Office Action Summary

10/525,251

PERRIN, RICHARD

DETAILED ACTION

(fig. 3, of Magill)

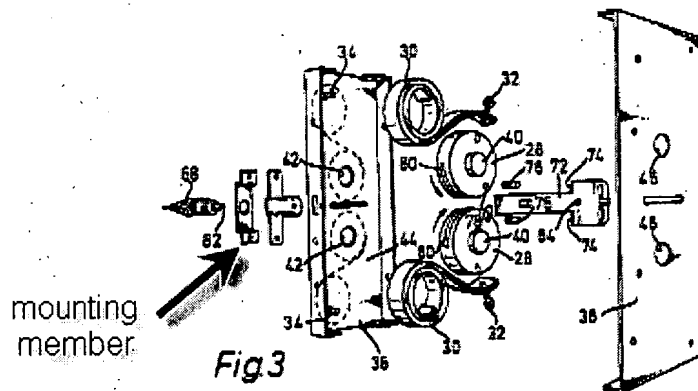
Regarding claim 47, the body member comprises a cylindrical casing (86) mounted by a mounting member (fig. 3, see paragraph below where the examiner labeled originally not labeled element with darkened arrow), said opening in the exterior of the body member being in the mounting member.

3. The examiner labeled originally not labeled elements for clarification:

(fig. 9 of Magill)

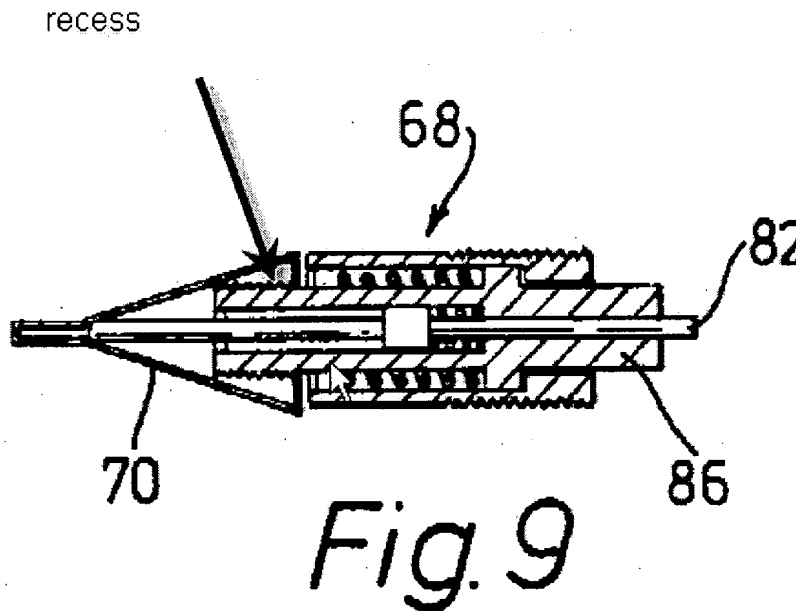
Regarding claim 52, the casing has a recess (see paragraph below where the examiner labeled originally not labeled elements for clarification with darkened arrows), the movable member is within the casing (figs. 9-11), and the head has a detent (triangle part of element 70) engaging in the recess such that when the heat-softenable or meltable material is soft or molten, a force on the head in a direction of its movement with respect to the casing would cam the detent out of the recess in a direction generally at right angles to the direction of movement of the head and release the head, thereby causing the movable member to move, the heat-softenable or meltable material being between the detent and the casing and being such that said force applies a force on the heat-softenable or meltable material generally at right angles to the direction of movement of the head.

Regarding claim 54, the head comprises an end piece (end on the right-hand part of element 70) which is adjacent or abuts the end of the movable member (fig. 9), the end piece having elongate detents (left side of the triangle 70) which extend outside the casing and parallel to the movable member (figs. 9-11).
